# UNITED STATES PATENT AND TRADEMARK OFFICE

### Office Action Summary

10/664,371

## DETAILED ACTION

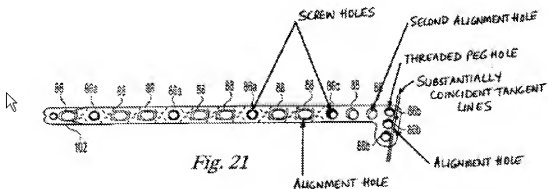
Claims 37-38, 45-48, 51 and 53-55 are rejected under 35 U.S.C. 102(e) as being anticipated by Weaver et al. (US 6,623,486).

Weaver et al. disclose a bone fixation plate 80 including: a head angled relative to a the shaft; the head portion defining a first set of threaded holes 86b; alignment holes much smaller in diameter than the threaded holes for provisional fixation of the bone plate; a second alignment hole 88; and a plurality of screw holes 86a in the shaft of the bone plate (Figs. 20-26, col. 6, lines 58-67 and col. 7, lines 1-17). See marked up Fig. 21 from Weaver et al. on the following page.

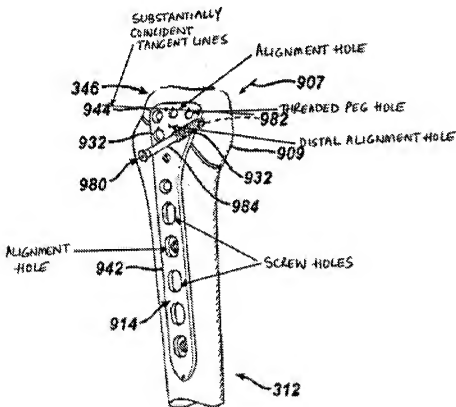
Claims 37-38, 40-43, 45-46, 48-51, 53-55, 58-59 and 65-69 are rejected under 35 U.S.C. 102(e) as being anticipated by Wack et al. (US 2004/0030339 A1).

Wack et al. disclose a plate 914 defining a first set of peg holes structurally adapted to engage a threaded head of a fixation peg and at least one non-threaded alignment hole 871 having a second relatively small diameter wherein the first alignment hole defines a tangent line substantially coincident with a line tangent to the first set of threaded (Figs. 20-22 and paras [0118]-[0162]). See a portion of Fig. 20 marked up to show features of Applicant's invention below.
